**VIRGINIA ELECTRIC AND POWER COMPANY (DOMINION)**  
**SURRY AND NORTH ANNA POWER STATIONS UNITS 1 AND 2**  
**LICENSE RENEWAL APPLICATIONS**  
**SUPPLEMENTAL INFORMATION ON STATION BLACKOUT AND**  
**NON-EQ CABLE MONITORING PROGRAM**

**License Renewal – Revised Response to RAI 2.5-1  
Serial No. 02-297**

**Surry and North Anna Power Stations, Units 1 and 2  
License Renewal Applications**

**License Renewal – Supplemental Response to RAI 3.6.2-1  
Serial No. 02-297**

**Figure SPS-1  
 Surry Power Station**

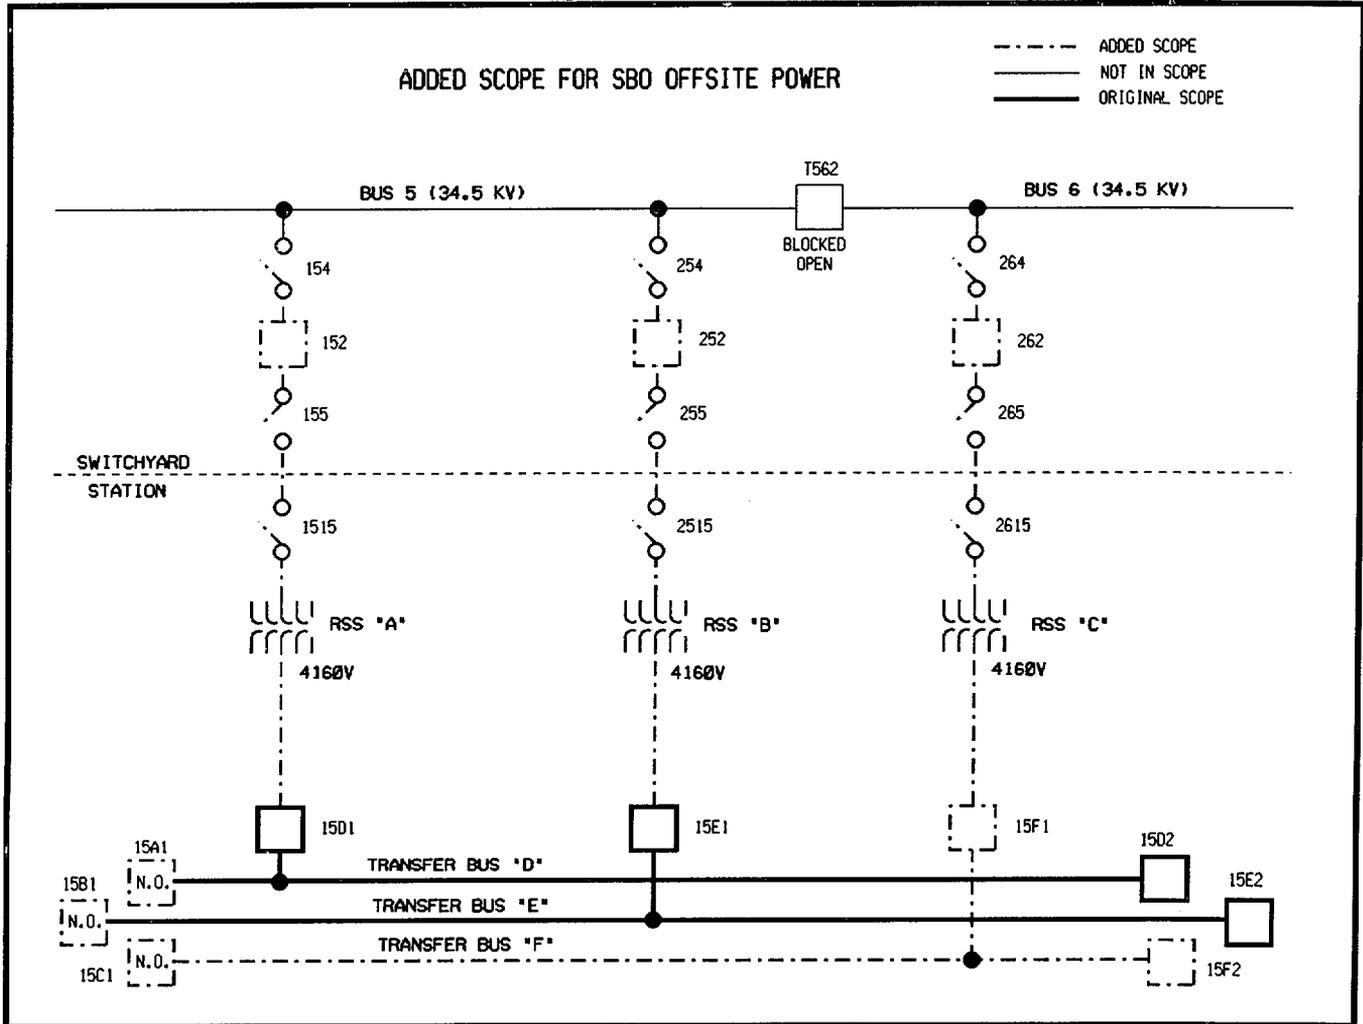
“The screening results in both license renewal application (LRA) for Section 2.5 do not include any electrical components listed in NEI 95-10 (Appendix B) and the Standard Review Plan (Table 2.1-5) associated with the offsite power system. These are components such as switchyard bus, transmission conductors, switchyard insulators and transmission line insulators. 10 CFR 54.4(a)(3) requires that all systems, structures, and components (SSCs) relied on in safety analyses or plant evaluations to perform a function that demonstrates compliance with the Commission’s regulation for station blackout (10 CFR 50.63) be included within the scope of Part 54. In 10 CFR 50.63 it’s required that each light-water-cooled nuclear power plant licensed to operate be able to withstand and recover from a station blackout of a specified duration that is based upon factors that include the expected frequency of loss of offsite power and the probable time needed to recover offsite power. At North Anna and Surry the specified duration was determined based upon evaluations that followed the guidance in NRC Regulatory Guide 1.155 and NUMARC 87-00, and included the plants’ offsite power characteristics. These characteristics helped determine the probable time needed to recover offsite power (coping duration). The resulting four hour coping duration at North Anna and Surry is, therefore, based on the likelihood of recovering offsite power within four hours following its loss. Therefore, identify where in the LRA these Station Blackout SSCs are included within the scope of license renewal, or provide a technical justification for excluding the Station Blackout SSCs from the screening results.”

For Surry, the additional offsite power path scope required to recover from an SBO event extends from the switchyard disconnect switches through the 34.5KV circuit breakers to the RSSTs and continues to Transfer Buses D, E, and F. Transfer Buses D and E and their associated 4160V circuit breakers and controls are already within the SBO equipment scope of license renewal. Figure SPS-1 provides an excerpt from the Surry one-line integrated schematic electrical drawing and shows the boundary of the additional SBO offsite power path scope.

1. 34.5KV circuit breakers with associated control components (including cables) and disconnect switches to connect the RSST circuits to the grid.
2. 34.5KV power conductors (insulated cable, bare overhead cable, tubular bus, and connectors) from the switchyard to the RSSTs.
3. Power cables and connectors for sump pumps located in manholes associated with underground 34.5KV cable.
4. Ceramic insulators used with disconnect switches, overhead bare cable, and tubular bus for 34.5KV and 4160V circuits.
5. RSSTs, 4160V power conductors (tubular bus, insulated cable and connectors) that supply Transfer Buses D, E, and F, the 4160V breakers connecting to the transfer buses, and Transfer buses D, E, and F.
